REMARKS / ARGUMENTS

Amendments to the Drawings

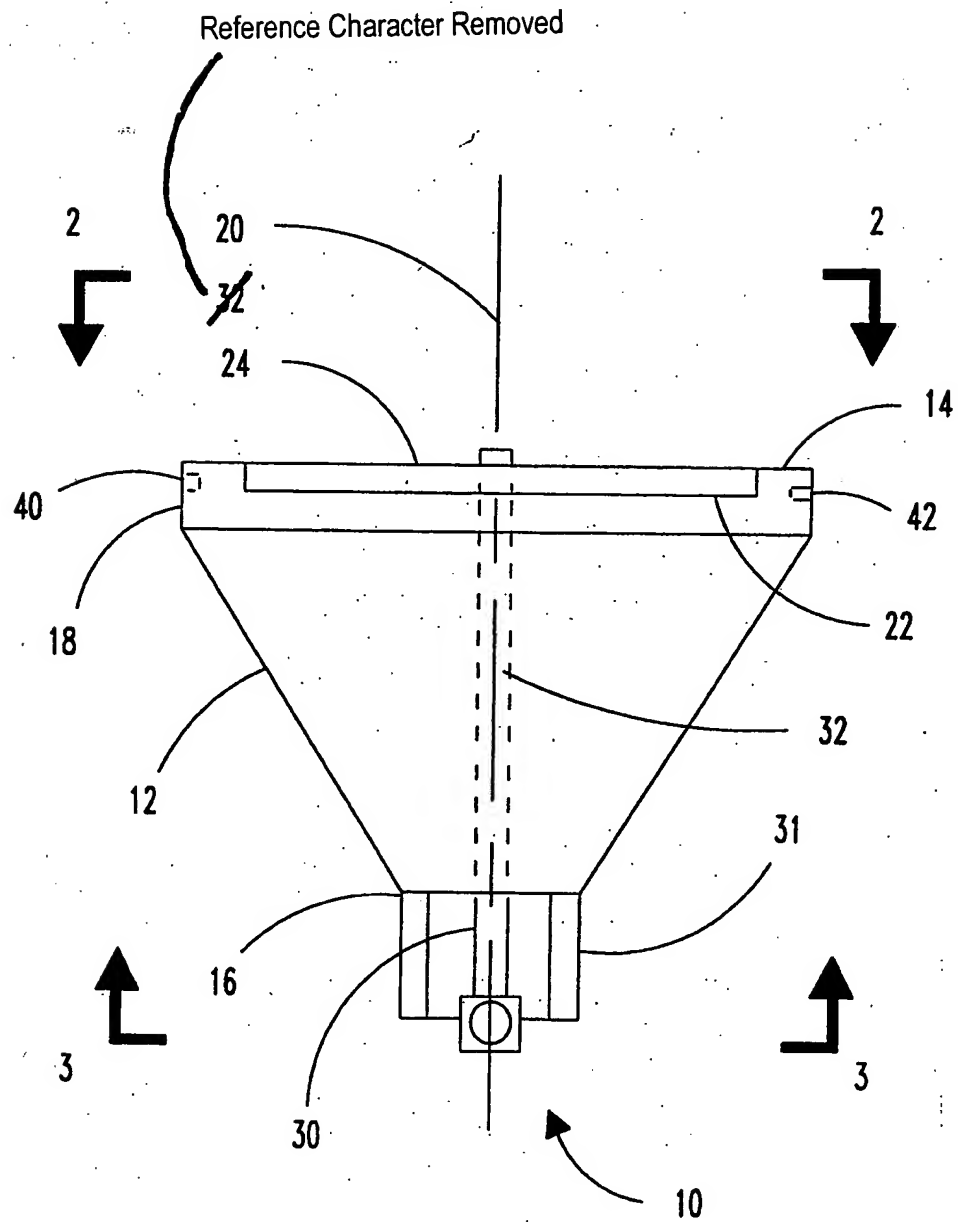
In the Office Action, the drawings were objected to because reference character "32" between "20" and "24" should be deleted in FIG. 1. Corrected drawing sheets in compliance with 37 CFR

In the Office Action, the drawings were objected to because reference character "32" between "20" and "24" should be deleted in FIG. 1. In response, FIG. 1 has been amended to delete reference character "32" between "20" and "24". It is submitted

The attached sheet of drawings includes changes to FIGS. 1 and 4. In FIG. 1, reference character "32" has been removed. In FIG. 4, reference character "(54)" has been changed to "(55)".

FIG. 4

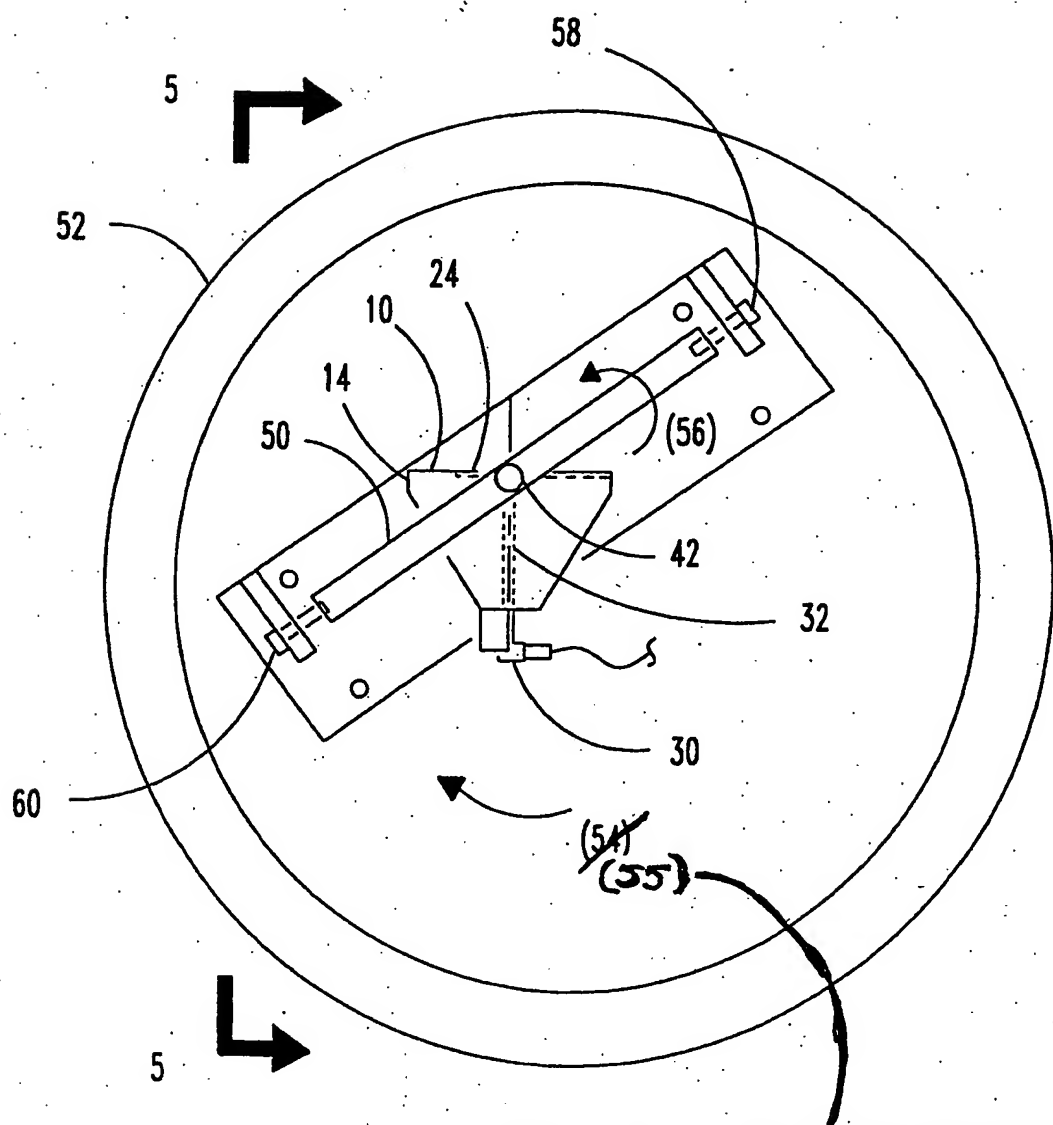
In the Office Action, the drawings were objected to as failing to comply with 37 CFR 1.84(p)(4) because reference character "54" has been used to designate both a tow body and gravity(See Page 11). Corrected drawing sheets in compliance with 37 CFR 1.121(d) are required in reply to the Office action to avoid abandonment of the application. Any amended replacement drawing sheet should include all of the figures appearing on the immediate prior version of the sheet, even if only one figure is being amended. Each drawing sheet submitted after the filing date of an application must be labeled in the top margin as either "Replacement Sheet" or "New Sheet" pursuant to 37 CFR 1.121(d). If the changes are not accepted by the examiner, the applicant will be notified and informed on any required corrective action in the next Office action. The objection to the drawings will not be held in abeyance.

Reference Character Changed

In the Office Action, the drawings were objected to as failing to comply with 37 CFR 1.84(p)(4) because reference character "54" has been used to designate both a tow body and gravity (See Page 11). In response, FIG. 4 and the corresponding text in the specification has been amended to change reference character "(54)" to "(55)" to designate the swinging arc by gravity. It is submitted that amended changes to FIG. 4 and the corresponding text in the specification do not add new matter and that the objection of the Office Action is resolved.
